Technical Bulletin 168

05.2016

Contents

Item: 168.3

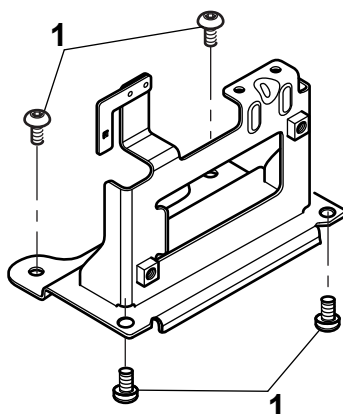
The torque figure has changed. If loosened or removed for any reason the encapsulated fixing(s) must be replaced .

Tighten the fixings to **7 Nm**.

Item: 168.4

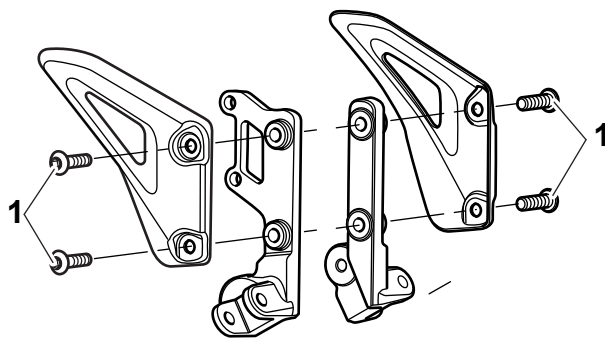
The torque figure has changed. If loosened or removed for any reason the fixing(s) must be torqued as required.

Tighten the fixings to **19 Nm**.

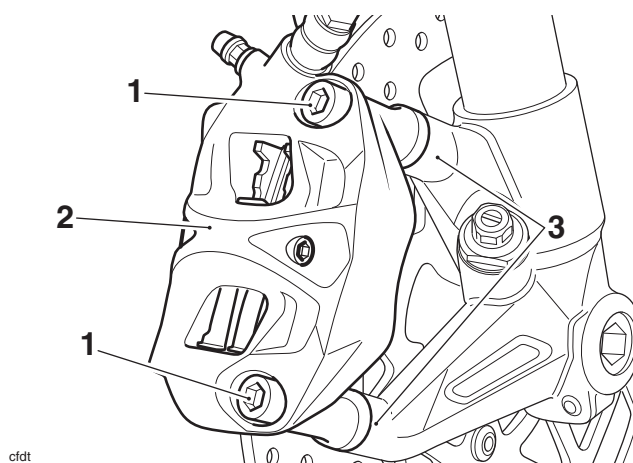
If for any reason a radial front brake caliper is removed the brake pads may become incorrectly aligned to the brake disc causing uneven wear to the brake pads. Therefore when replacing the brake pads or refitting the brake caliper(s) for any reason it is necessary to follow the procedure listed below.

-
5. Hold the front brake lever in the on position to align the brake pads to the disc(s) and tighten the bolts to **55 Nm** .

Item:	168.6
Description:	Gear Selector Drum Kit
Model Affected:	Trophy, Trophy SE, Tiger Explorer XC, Tiger Explorer XR, Tiger Explorer XRX, Tiger Explorer XCX, Tiger Explorer XRT, Tiger Explorer XCA, Tiger Explorer XRX LRH, Tiger Explorer XCX LRH

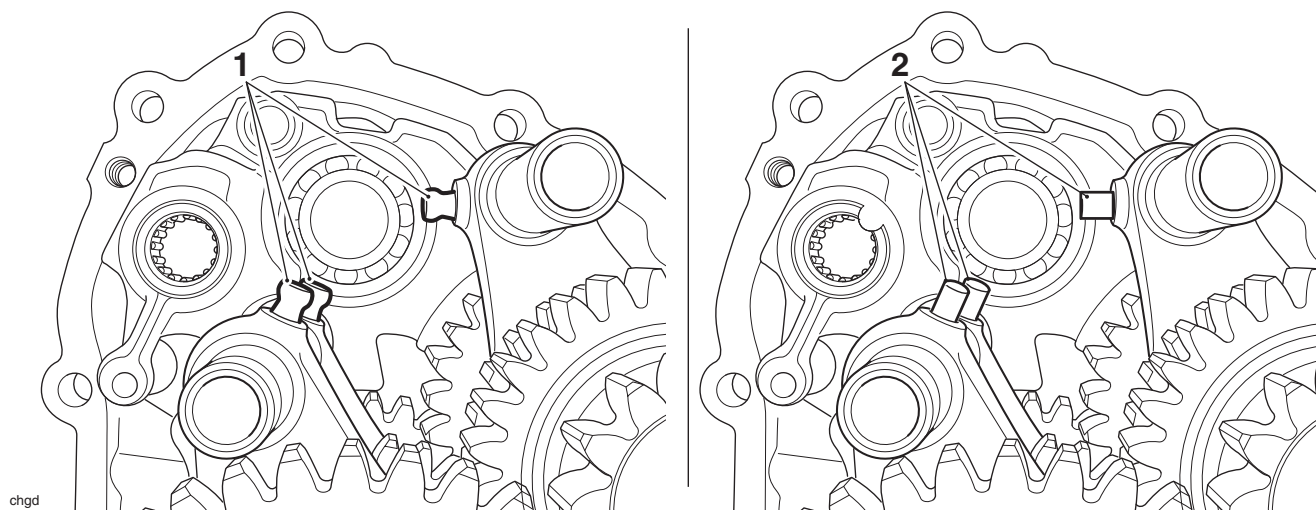
A new selector drum, input selector fork, output selector forks and detent spring has been introduced on the above model from engine number 752515. The new selector drum, input selector fork, output selector forks and detent spring are retrofittable to all earlier engine numbers, but only when fitted as part of a kit. To facilitate this, parts kit T1195566 has been released for use with the above models up to engine number 752514.

1. Spring up to engine number 752514
2. Spring from engine number 752515

- 1. Selector Fork (old condition)**
- 2. Selector Fork (new condition)**

Item: 168.7

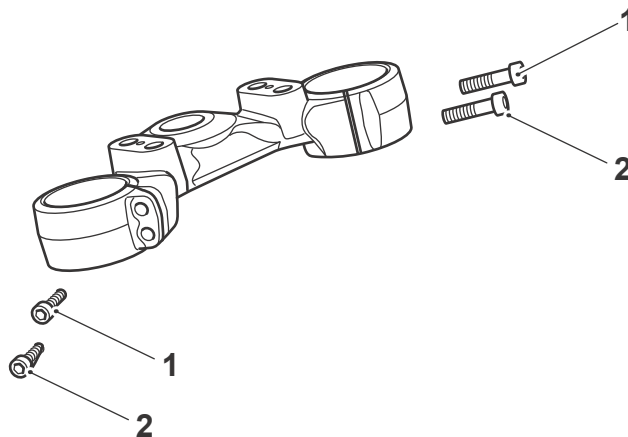
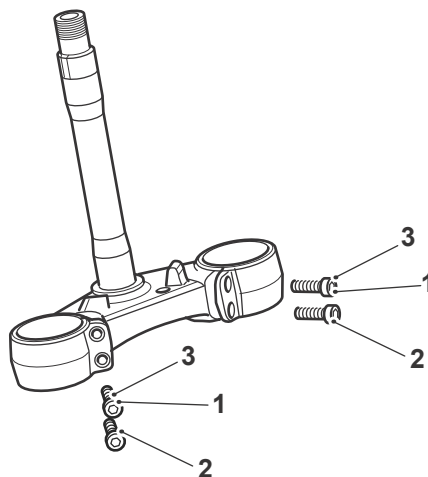
A new tightening sequence has been released for the upper and lower yoke pinch bolts.

1. Tighten the upper pinch bolt to the torque specified in the service manual.
2. Tighten the lower pinch bolt to the torque specified in the service manual.

1. Tighten the upper pinch bolt to the torque specified in the service manual.
2. Tighten the lower pinch bolt to the torque specified in the service manual.
3. Retighten the upper pinch bolt to the torque specified in the service manual.

Item: 168.8

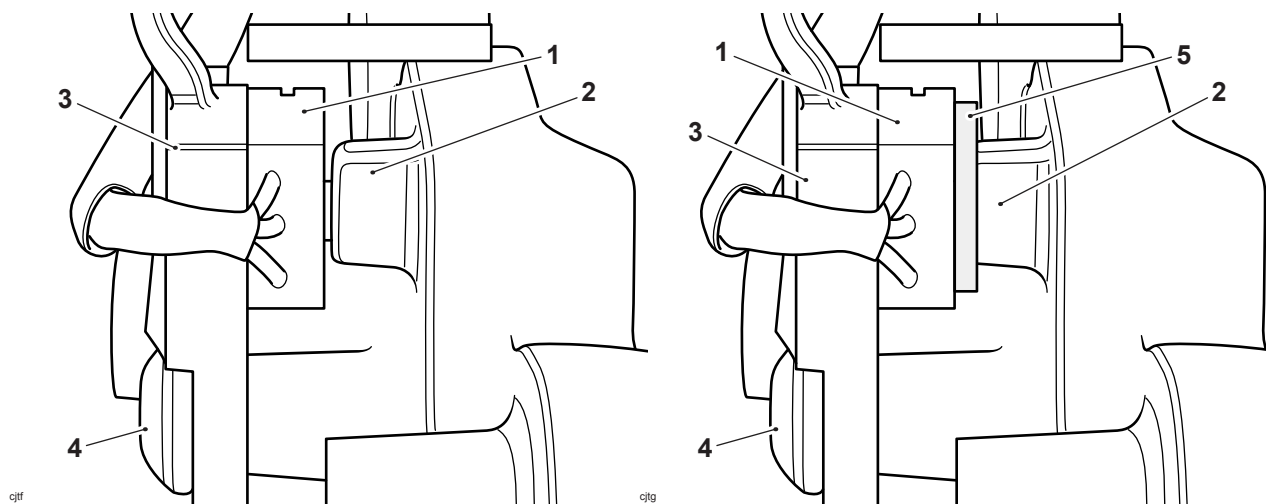
A self adhesive foam pad part number T3660288 has been added to the rear brake light switch. The self adhesive foam pad is fastened to the switch to reduce the tolerance between the master cylinder carrier bracket and the switch body. If for any reason the rear brake light flickers a foam pad should be fitted as shown below.

1. Brake light switch (Speed Triple R shown)
2. Master cylinder carrier bracket, master cylinder removed for clarity
3. Adjuster plate
4. Fixing
5. Self adhesive foam pad (T3660288)

Item: 168.9
Description: Rear Brake Switch
Model Affected: Thruxton 1200, Thruxton 1200 R

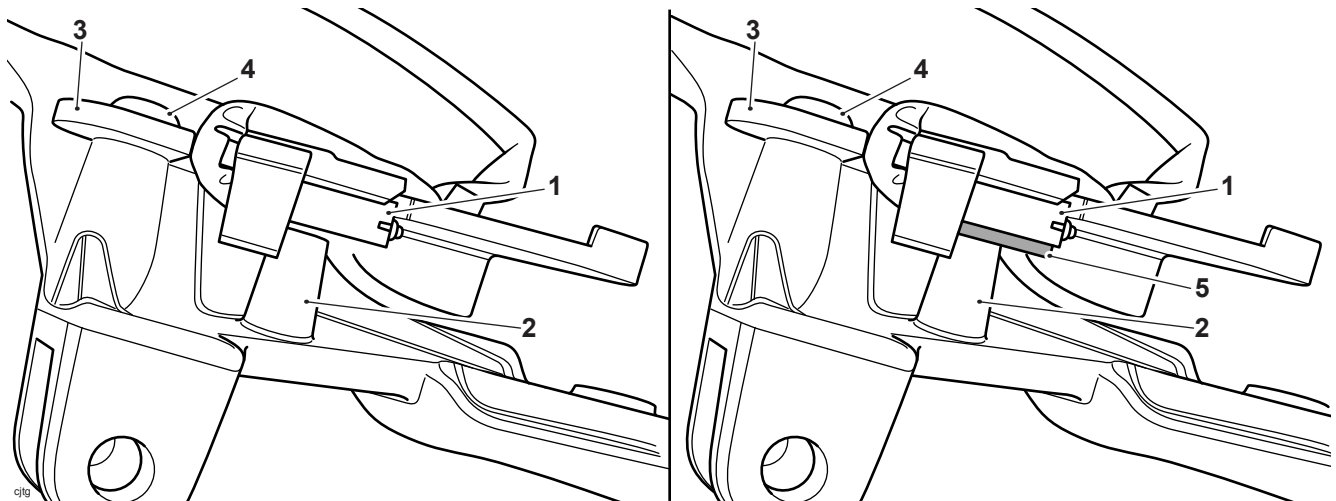
A self adhesive foam pad part number T3660288 has been added to the rear brake light switch. The self adhesive foam pad is fastened to the switch to reduce the tolerance between the master cylinder carrier bracket and the switch body. If for any reason the rear brake light flickers a foam pad should be fitted as shown below.

1. Brake light switch
2. Master cylinder carrier bracket, master cylinder removed for clarity
3. Adjuster plate
4. Fixing
5. Self adhesive foam pad (T3660288)

Item: 168.10

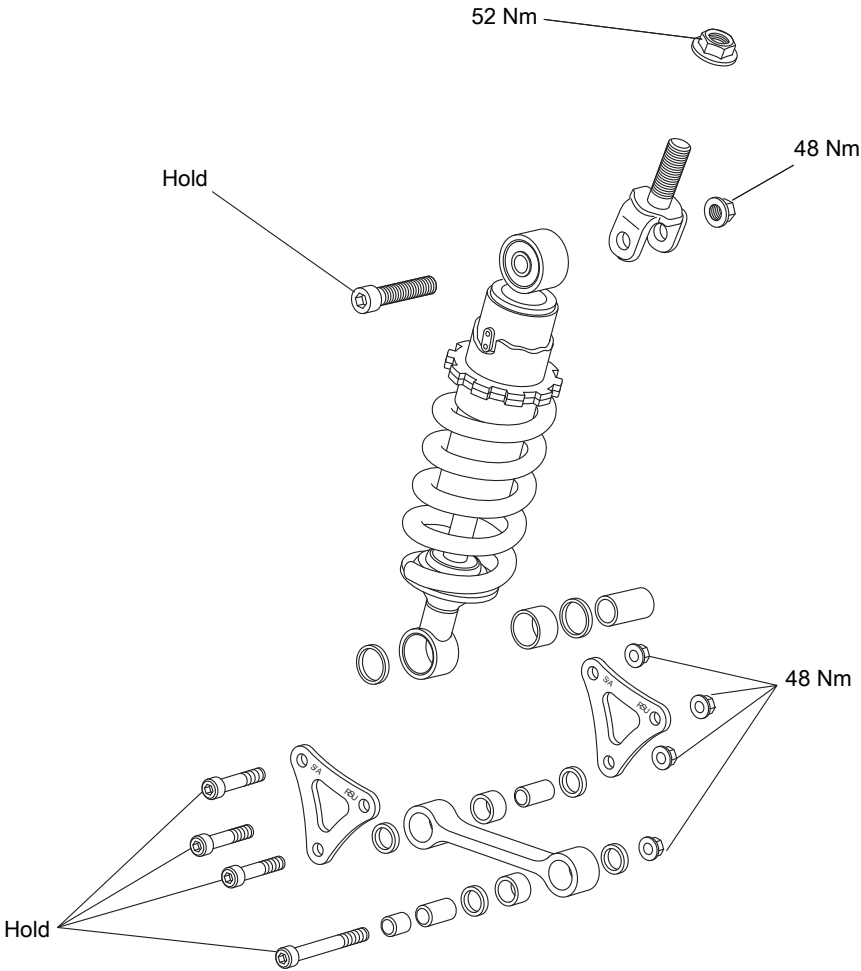
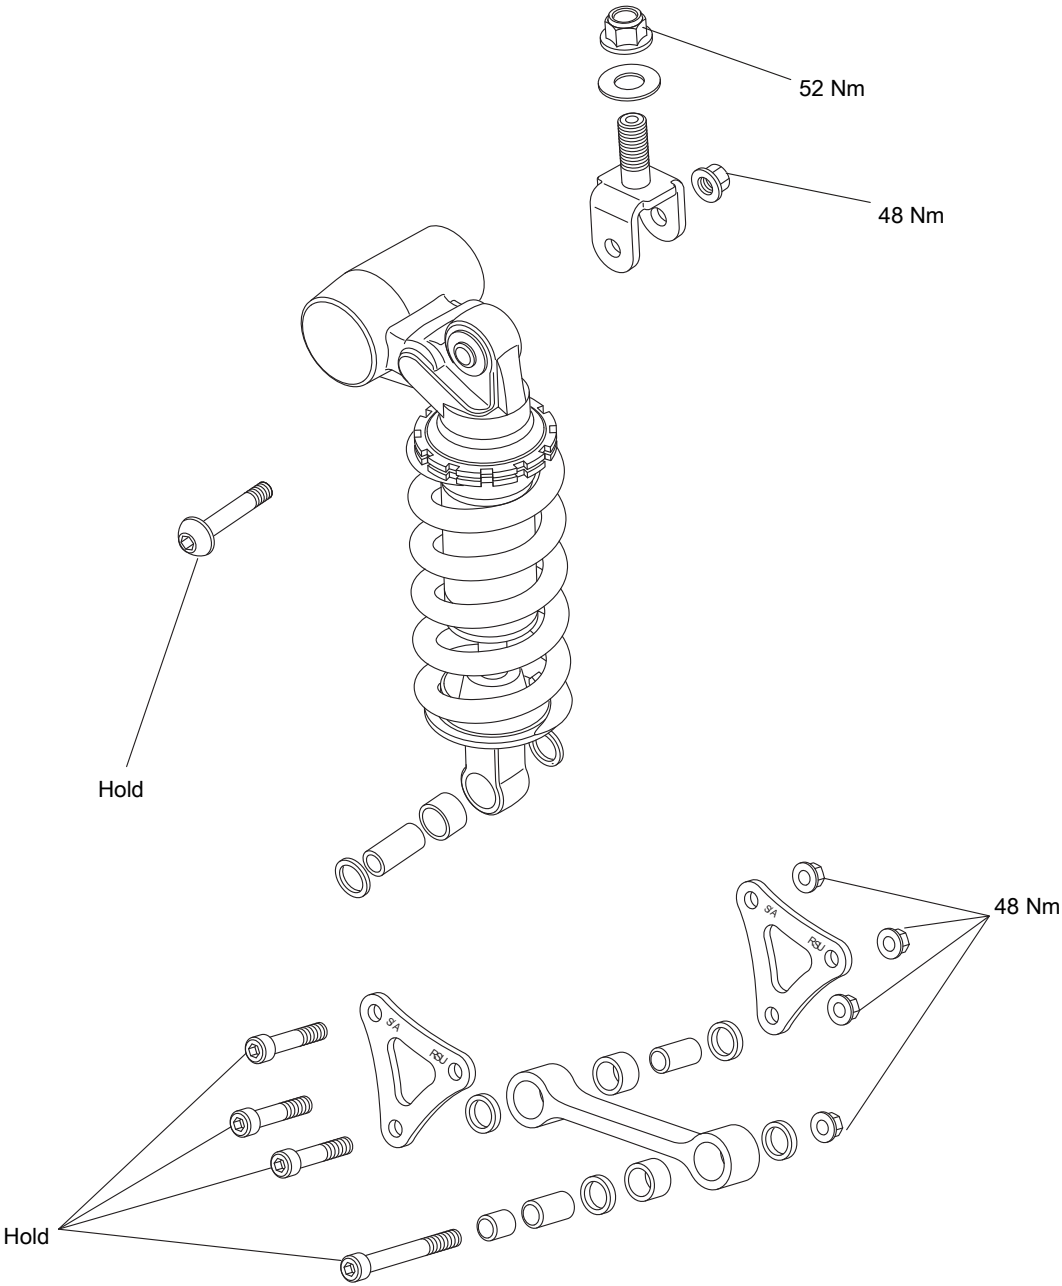
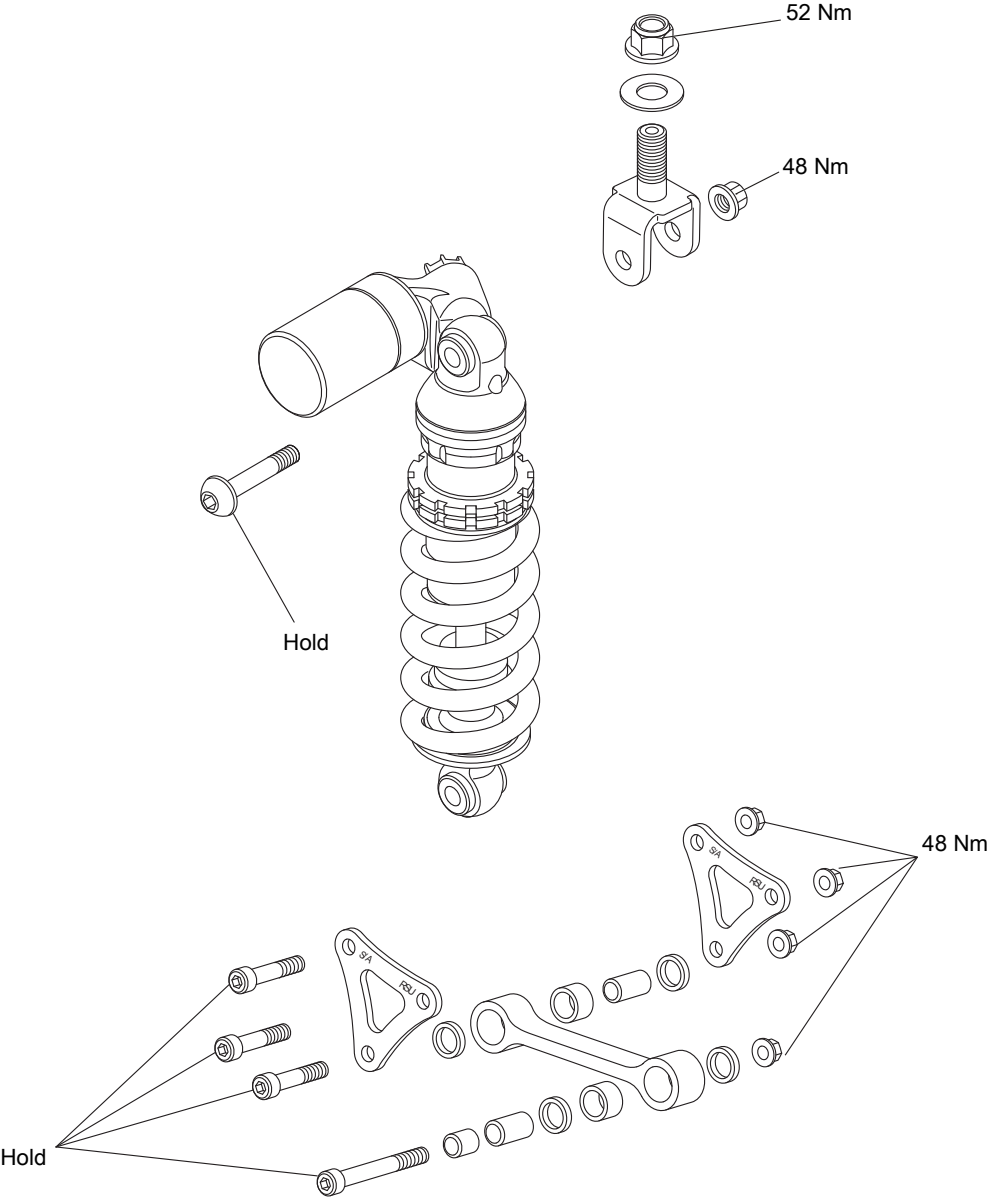
When installing the rear suspension drag link and drop links, follow the procedure described in the Service Manual noting the following tightening sequence:

- When tightening the drag link and drop link fixings, hold the bolts to prevent rotation, while tightening the nuts to **48 Nm**.

Item: 168.11

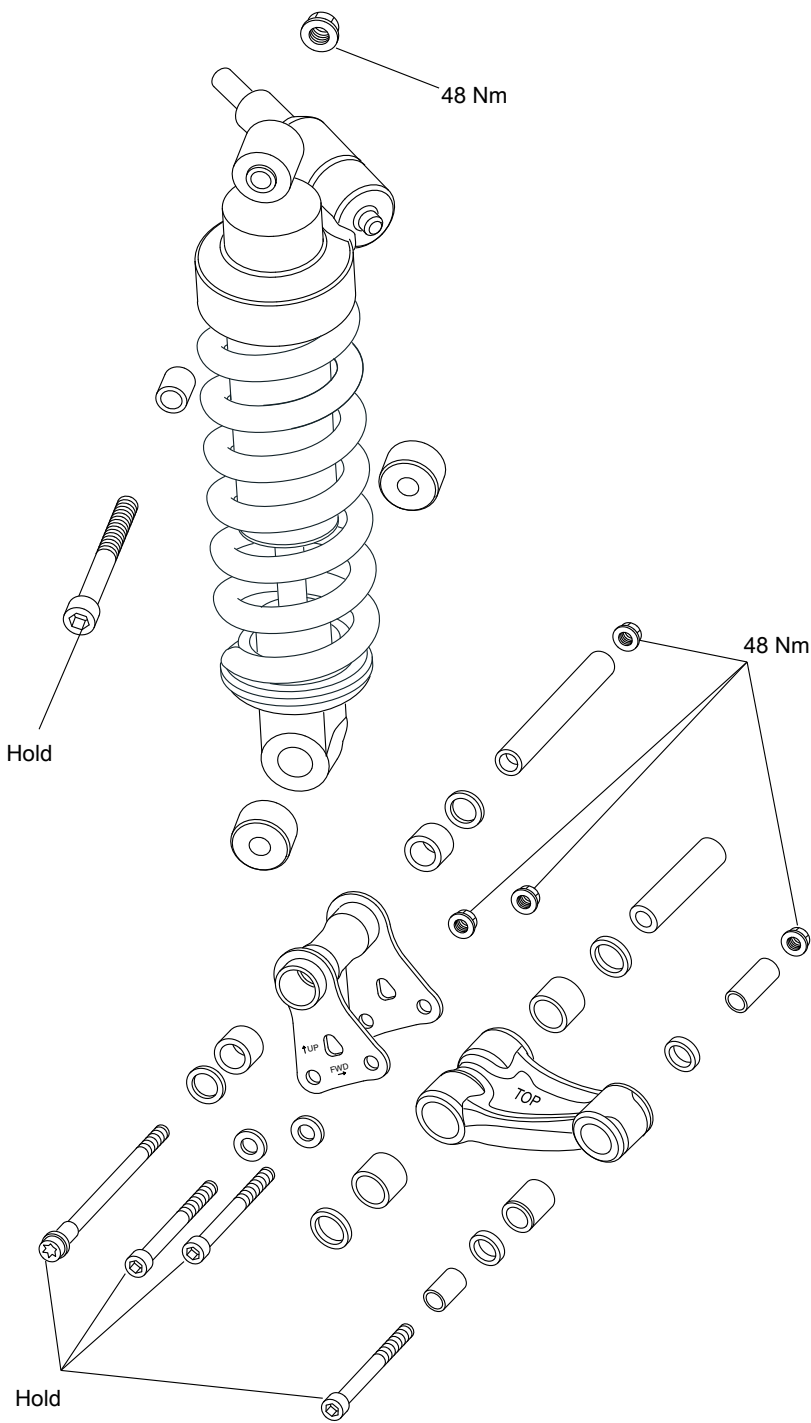
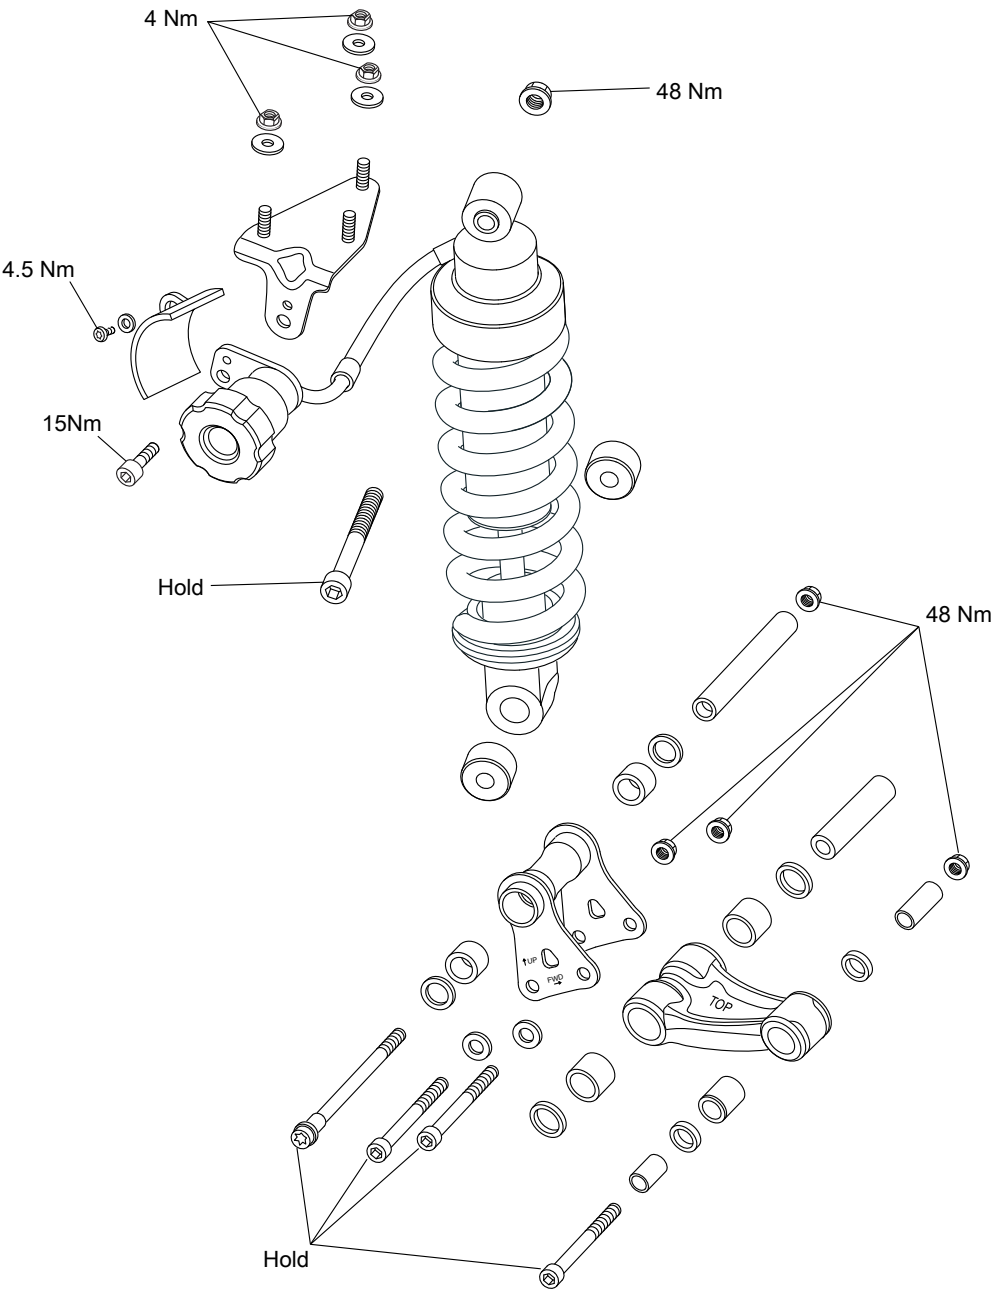
When installing the rear suspension drag link and drop links, follow the procedure described in the Service Manual noting the following tightening sequence:

- When tightening the drag link and drop link fixings, hold the bolts to prevent rotation, while tightening the nuts to **48 Nm**.

Item: 168.12

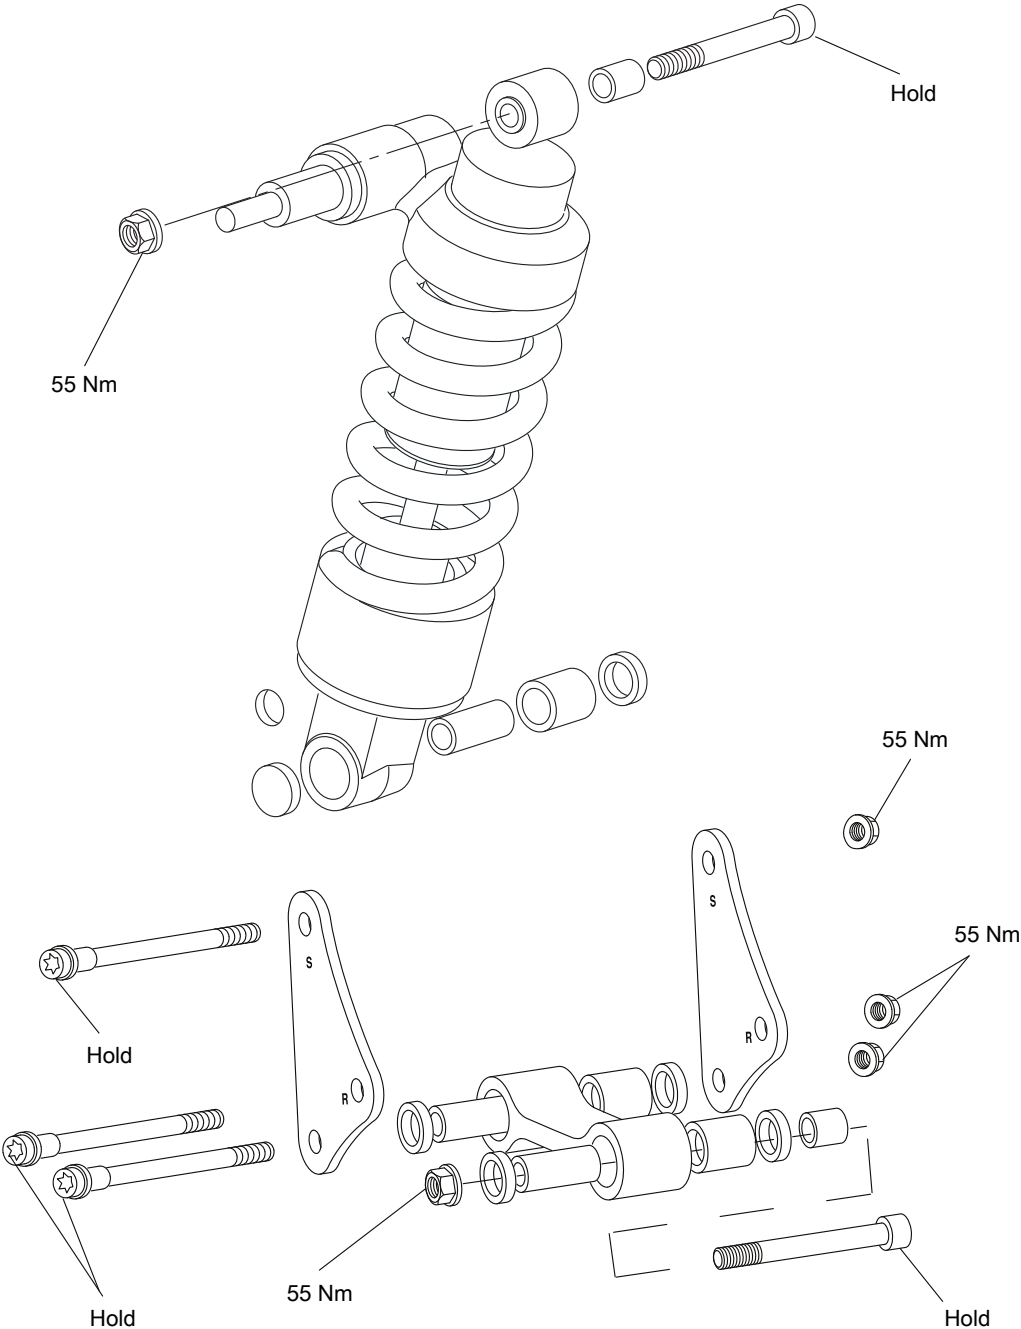
When installing the rear suspension drag link and drop links, follow the procedure described in the Service Manual noting the following tightening sequence:

- When tightening the drag link and drop link fixings, hold the bolts to prevent rotation, while tightening the nuts to **55 Nm**.
